# Value Engineering Study

**East Side Coastal Resiliency Project**

Preliminary  
Value Engineering Study Report  
for

East Side Coastal Resiliency Project  
New York, NY

**Reach H**  
**Sections: Preliminary**  
54

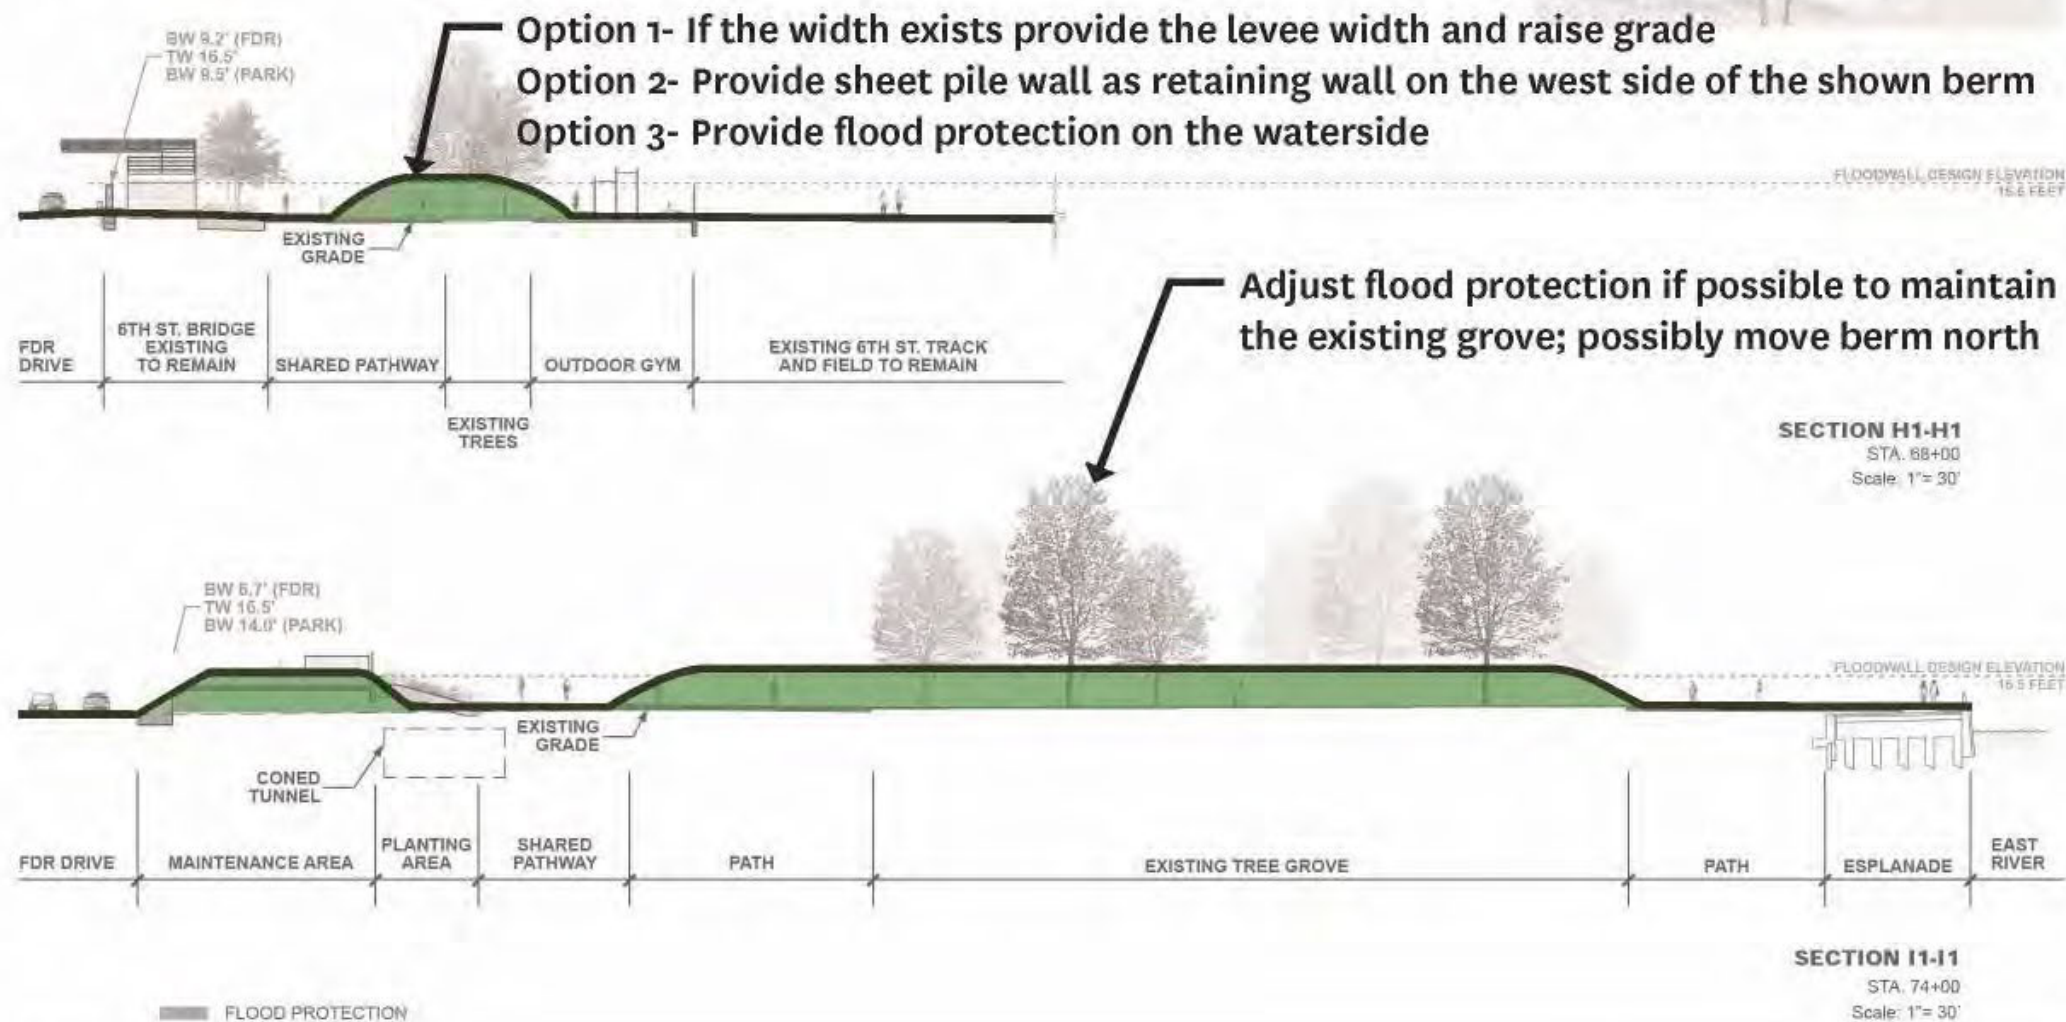
**Raise Park to elevation 16.5 to provide flood protection**  
(Elevation can be less in some places once levee requirements are met)

Swing gate detail taken from sheet FG150

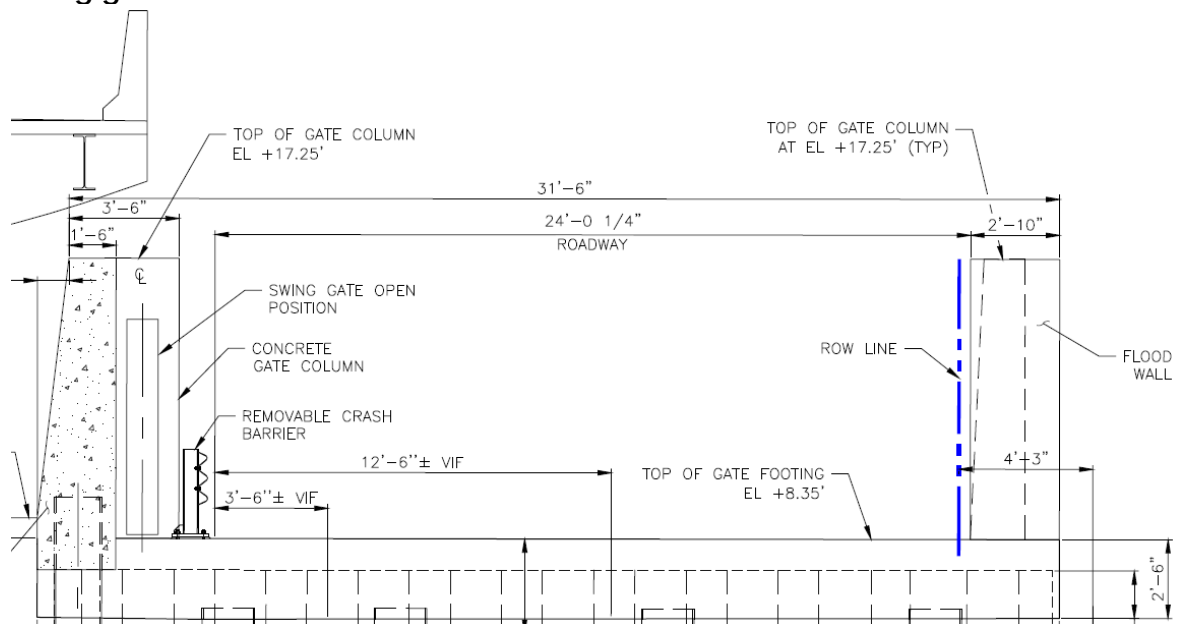
Specialized design will be required to provide redundant systems. Special care should be taken for any self-actuating gates to ensure public safety (traffic control in anticipation of actuation, etc.).
